Town of Parker
SALISBURY PARK NORTH - PHASE 1
11700 MOTSENBOCKER RD
PARKER, CO 80134

PHASE 1 DETAILED GRADING & DRAINAGE PLAN

SITE PLAN SUBMITTAL
Page 51 of 311

PHASE 1 STORM PLAN & PROFILE

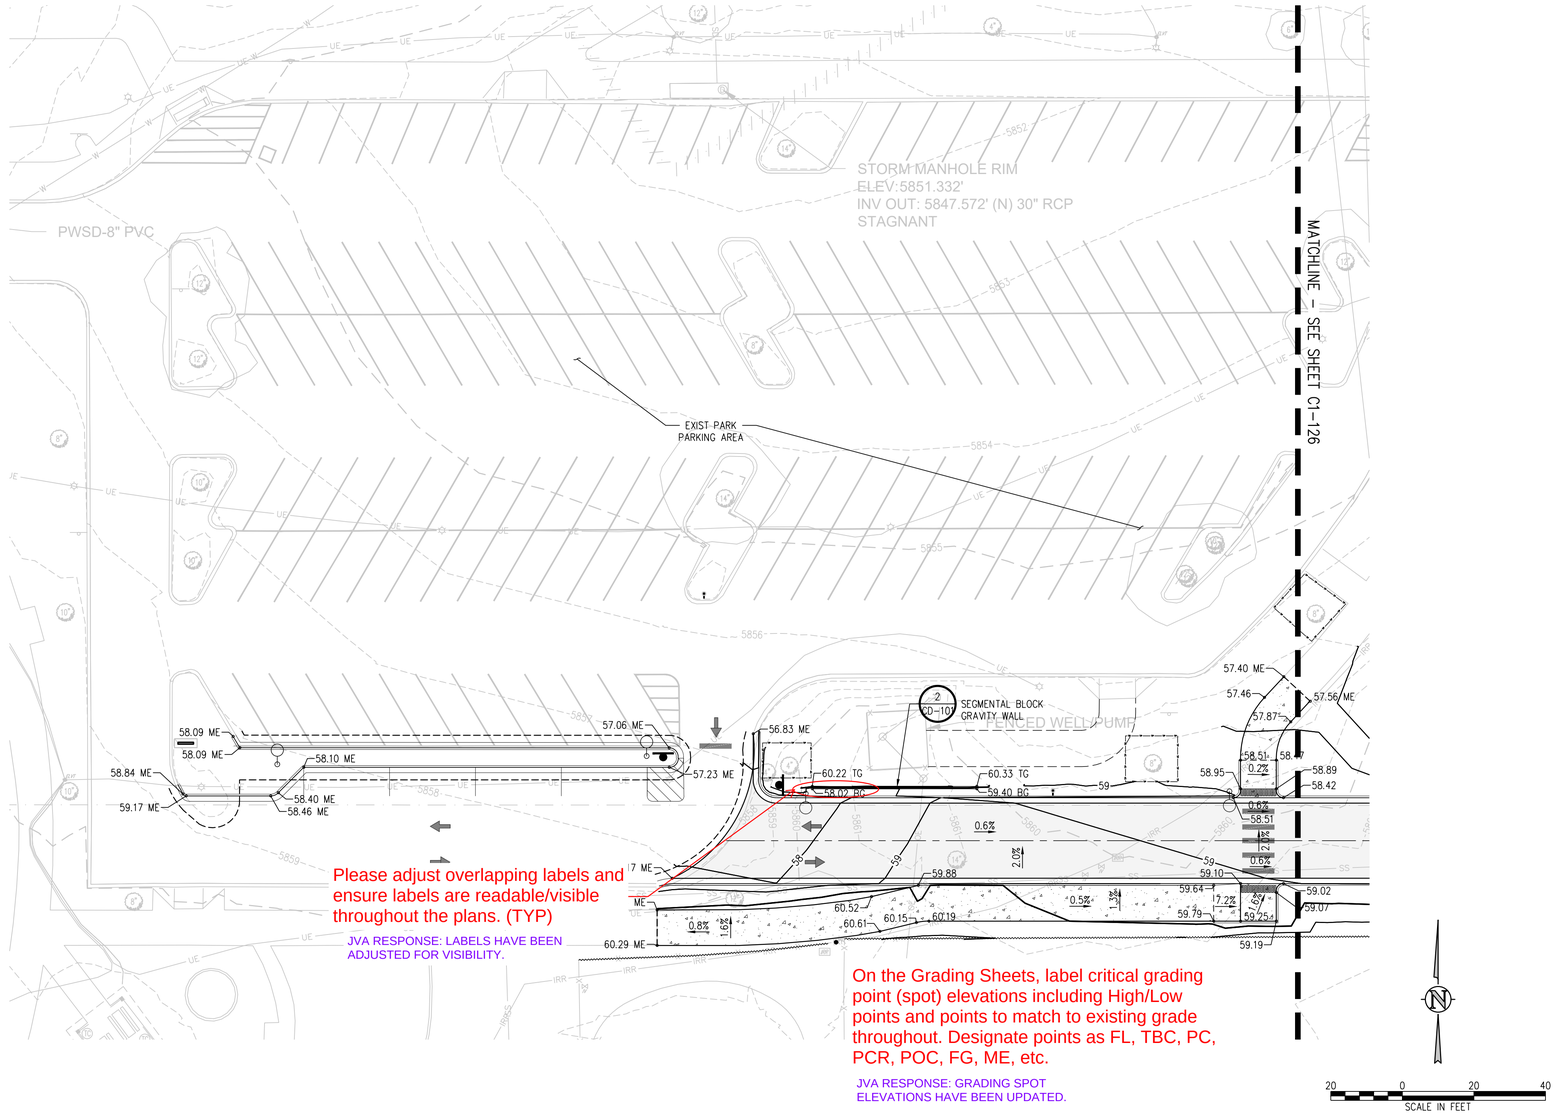
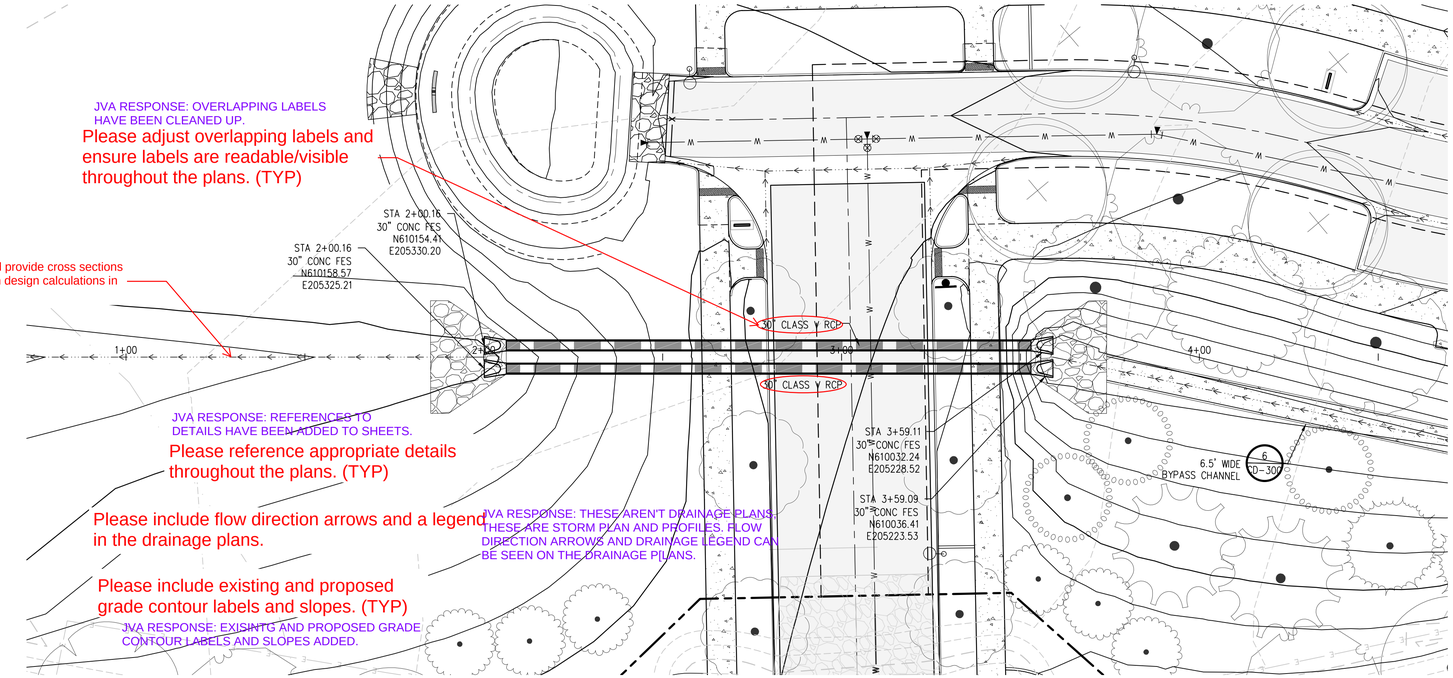
Please adjust overlapping labels and ensure labels are readable/visible throughout the plans. (TYP)

On the Grading Sheets, label critical grading point (spot) elevations including High/Low points and points to match to existing grade throughout. Designate points as FL, TBC, PC, PCR, POC, FG, ME, etc.

JVA RESPONSE: LABELS HAVE BEEN ADJUSTED FOR VISIBILITY.

JVA RESPONSE: GRADING SPOT ELEVATIONS HAVE BEEN UPDATED.

STORM BYPASS PROFILE
SCALE: 1" = 20' HORIZ
1" = 5' VERT

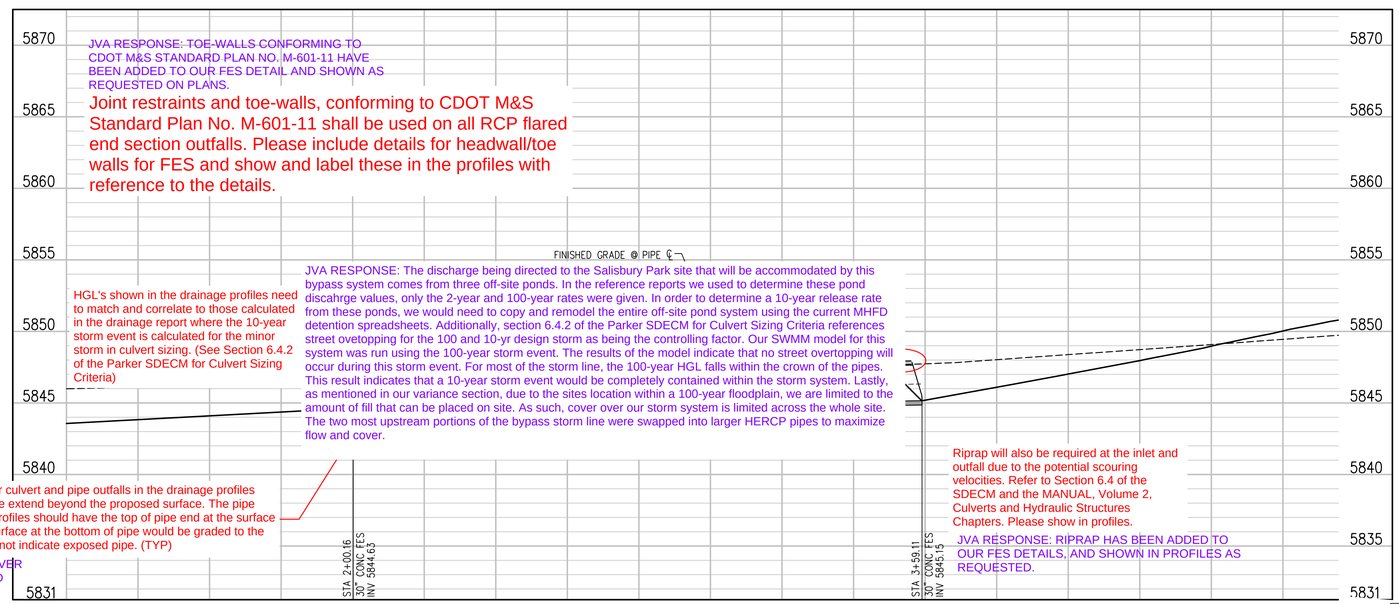
Please include a Key Map for maps that consist of plan views showing a portion of the overall site

Please adjust overlapping labels and ensure labels are readable/visible throughout the plans. (TYP)

Please reference appropriate details throughout the plans. (TYP)

Please include flow direction arrows and a legend in the drainage plans.

Joint restraints and toe-walls, conforming to CDOT M&S Standard Plan No. M-601-11 shall be used on all RCP flared end section outfalls. Please include details for headwall/toe walls for FES and show and label these in the profiles with reference to the details.

Riprap will also be required at the inlet and outfall due to the potential scouring velocities. Refer to Section 6.4 of the SDECM and the MANUAL, Volume 2, Culverts and Hydraulic Structures Chapters. Please show in profiles.

JVA RESPONSE: KEY MAP CAN BE SEEN IN THE BOTTOM OF THE TITLE BLOCK

JVA RESPONSE: OVERLAPPING LABELS HAVE BEEN CLEANED UP.

JVA RESPONSE: REFERENCES TO DETAILS HAVE BEEN ADDED TO SHEETS.

JVA RESPONSE: THESE AREN'T DRAINAGE PLANS. THESE ARE STORM PLAN AND PROFILES. FLOW DIRECTION ARROWS AND DRAINAGE LEGEND CAN BE SEEN ON THE DRAINAGE PLANS.

JVA RESPONSE: EXISINTG AND PROPOSED GRADE CONTOUR LABELS AND SLOPES ADDED.

JVA RESPONSE: TOE-WALLS CONFORMING TO CDOT M&S STANDARD PLAN NO. M-601-11 HAVE BEEN ADDED TO OUR FES DETAIL AND SHOWN AS REQUESTED ON PLANS.

JVA RESPONSE: The discharge being directed to the Salisbury Park site that will be accommodated by this bypass system comes from three off-site ponds. In the reference reports we used to determine these pond discahrge values, only the 2-year and 100-year rates were given. In order to determine a 10-year release rate from these ponds, we would need to copy and remodel the entire off-site pond system using the current MHFD detention spreadsheets. Additionally, section 6.4.2 of the Parker SDECM for Culvert Sizing Criteria references street ovetopping for the 100 and 10-yr design storm as being the controlling factor. Our SWMM model for this system was run using the 100-year storm event. The results of the model indicate that no street overtopping will occur during this storm event. For most of the storm line, the 100-year HGL falls within the crown of the pipes. This result indicates that a 10-year storm event would be completely contained within the storm system. Lastly, as mentioned in our variance section, due to the sites location within a 100-year floodplain, we are limited to the amount of fill that can be placed on site. As such, cover over our storm system is limited across the whole site. The two most upstream portions of the bypass storm line were swapped into larger HERCP pipes to maximize flow and cover.

JVA RESPONSE: COVER ISSUES ADDRESSED

JVA RESPONSE: RIPRAP HAS BEEN ADDED TO OUR FES DETAILS, AND SHOWN IN PROFILES AS REQUESTED.

STORM BYPASS PLAN

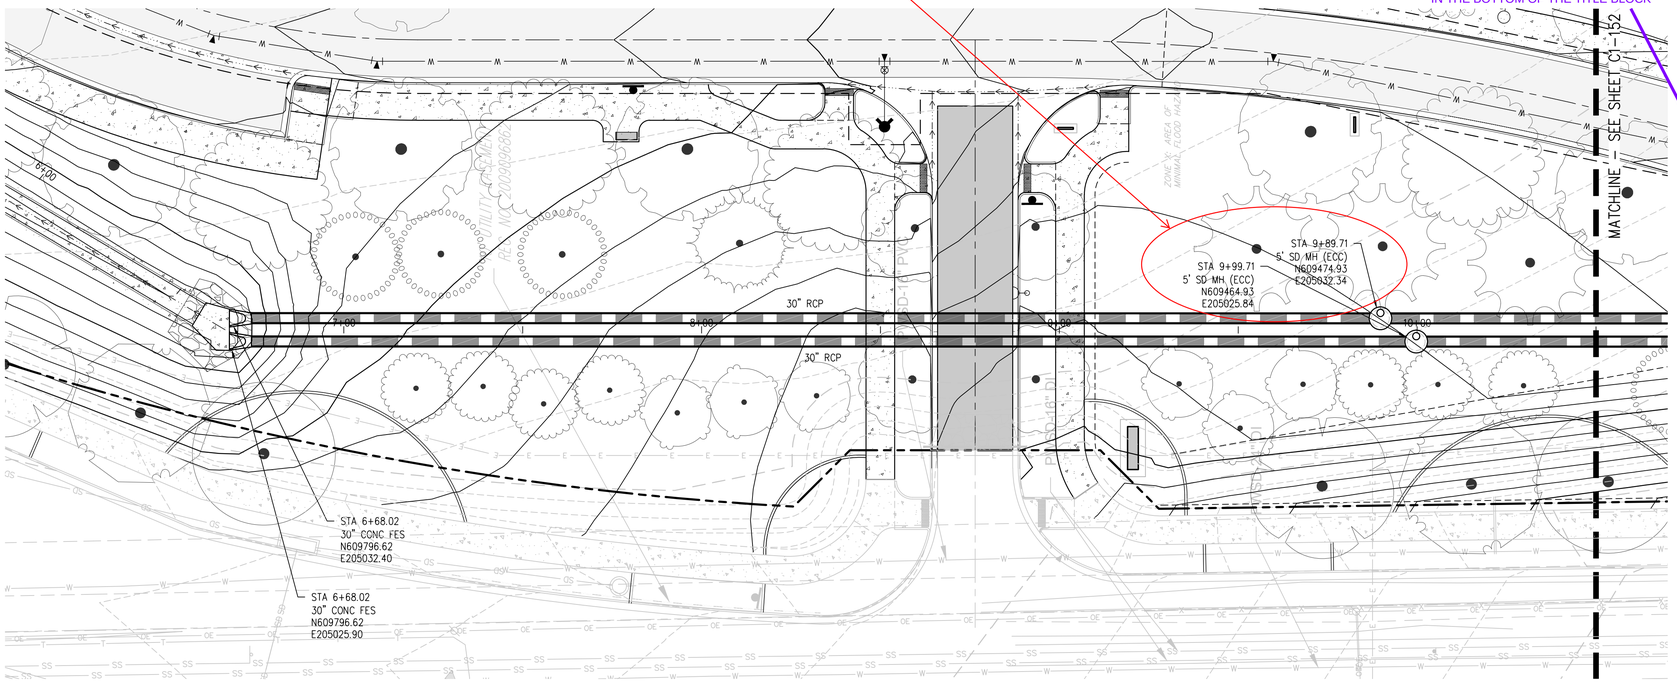
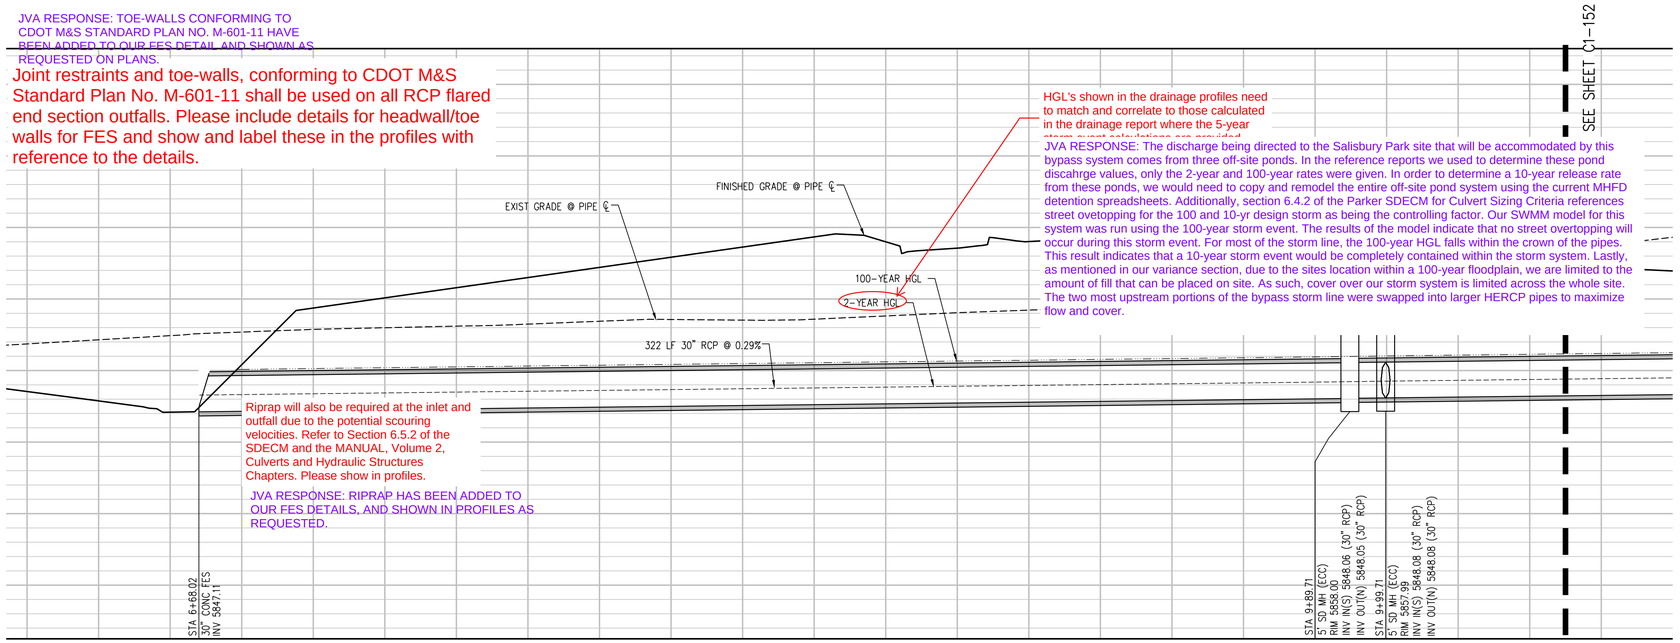
Please adjust overlapping labels and ensure labels are readable/visible throughout the plans. (TYP)

Please include a Key Map for maps that consist of plan views showing a portion of the overall site

Please include flow direction arrows and a legend in the drainage plans.

Joint restraints and toe-walls, conforming to CDOT M&S Standard Plan No. M-601-11 shall be used on all RCP flared end section outfalls. Please include details for headwall/toe walls for FES and show and label these in the profiles with reference to the details.

Riprap will also be required at the inlet and outfall due to the potential scouring velocities. Refer to Section 6.5.2 of the SDECM and the MANUAL, Volume 2, Culverts and Hydraulic Structures Chapters. Please show in profiles.

JVA RESPONSE: OVERLAPPING LABELS HAVE BEEN CLEANED UP.

JVA RESPONSE: KEY MAP CAN BE SEEN IN THE BOTTOM OF THE TITLE BLOCK

JVA RESPONSE: THESE AREN'T DRAINAGE PLANS, THESE ARE STORM PLAN AND PROFILES. FLOW DIRECTION ARROWS AND DRAINAGE LEGEND CAN BE SEEN ON THE DRAINAGE P[LANS.

JVA RESPONSE: EXISINTG AND PROPOSED GRADE CONTOUR LABELS AND SLOPES ADDED.

JVA RESPONSE: TOE-WALLS CONFORMING TO CDOT M&S STANDARD PLAN NO. M-601-11 HAVE BEEN ADDED TO OUR FES DETAIL AND SHOWN AS REQUESTED ON PLANS.

JVA RESPONSE: The discharge being directed to the Salisbury Park site that will be accommodated by this bypass system comes from three off-site ponds. In the reference reports we used to determine these pond discahrge values, only the 2-year and 100-year rates were given. In order to determine a 10-year release rate from these ponds, we would need to copy and remodel the entire off-site pond system using the current MHFD detention spreadsheets. Additionally, section 6.4.2 of the Parker SDECM for Culvert Sizing Criteria references street ovetopping for the 100 and 10-yr design storm as being the controlling factor. Our SWMM model for this system was run using the 100-year storm event. The results of the model indicate that no street overtopping will occur during this storm event. For most of the storm line, the 100-year HGL falls within the crown of the pipes. This result indicates that a 10-year storm event would be completely contained within the storm system. Lastly, as mentioned in our variance section, due to the sites location within a 100-year floodplain, we are limited to the amount of fill that can be placed on site. As such, cover over our storm system is limited across the whole site. The two most upstream portions of the bypass storm line were swapped into larger HERCP pipes to maximize flow and cover.

JVA RESPONSE: RIPRAP HAS BEEN ADDED TO OUR FES DETAILS, AND SHOWN IN PROFILES AS REQUESTED.

STORM BYPASS PROFILE
SCALE: 1" = 20' HORIZ
1" = 5' VERT

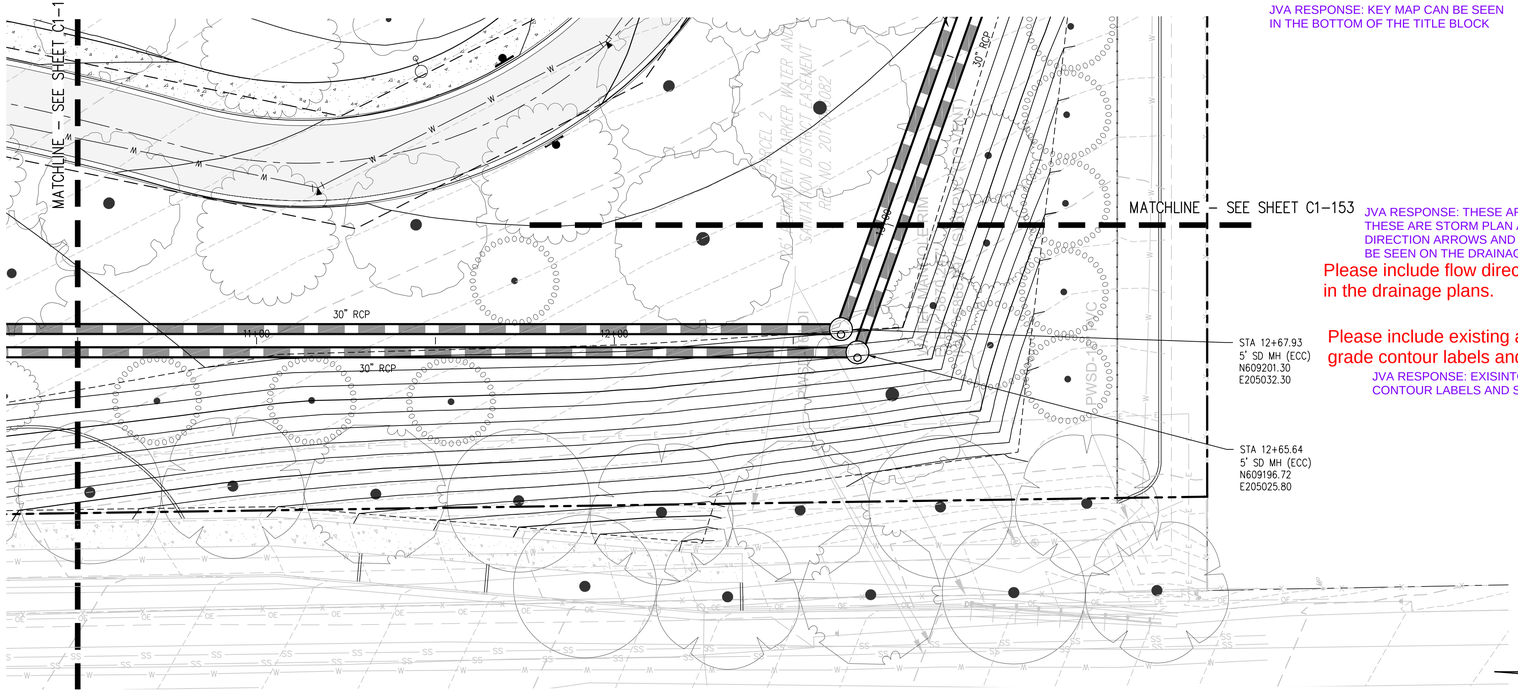
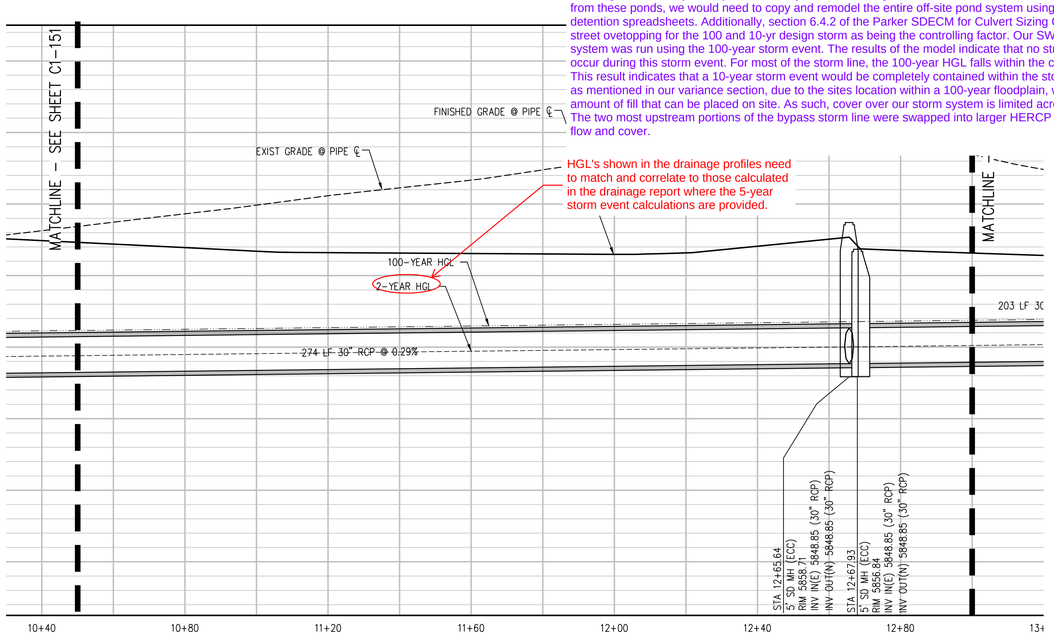
Please include a Key Map for maps that consist of plan views showing a portion of the overall site

Please include flow direction arrows and a legend in the drainage plans.

JVA RESPONSE: KEY MAP CAN BE SEEN IN THE BOTTOM OF THE TITLE BLOCK

JVA RESPONSE: THESE AREN'T DRAINAGE PLANS, THESE ARE STORM PLAN AND PROFILES. FLOW DIRECTION ARROWS AND DRAINAGE LEGEND CAN BE SEEN ON THE DRAINAGE P[LANS.

JVA RESPONSE: EXISINTG AND PROPOSED GRADE CONTOUR LABELS AND SLOPES ADDED.

JVA RESPONSE: The discharge being directed to the Salisbury Park site that will be accommodated by this bypass system comes from three off-site ponds. In the reference reports we used to determine these pond discahrge values, only the 2-year and 100-year rates were given. In order to determine a 10-year release rate from these ponds, we would need to copy and remodel the entire off-site pond system using the current MHFD detention spreadsheets. Additionally, section 6.4.2 of the Parker SDECM for Culvert Sizing Criteria references street ovetopping for the 100 and 10-yr design storm as being the controlling factor. Our SWMM model for this system was run using the 100-year storm event. The results of the model indicate that no street overtopping will occur during this storm event. For most of the storm line, the 100-year HGL falls within the crown of the pipes. This result indicates that a 10-year storm event would be completely contained within the storm system. Lastly, as mentioned in our variance section, due to the sites location within a 100-year floodplain, we are limited to the amount of fill that can be placed on site. As such, cover over our storm system is limited across the whole site. The two most upstream portions of the bypass storm line were swapped into larger HERCP pipes to maximize flow and cover.
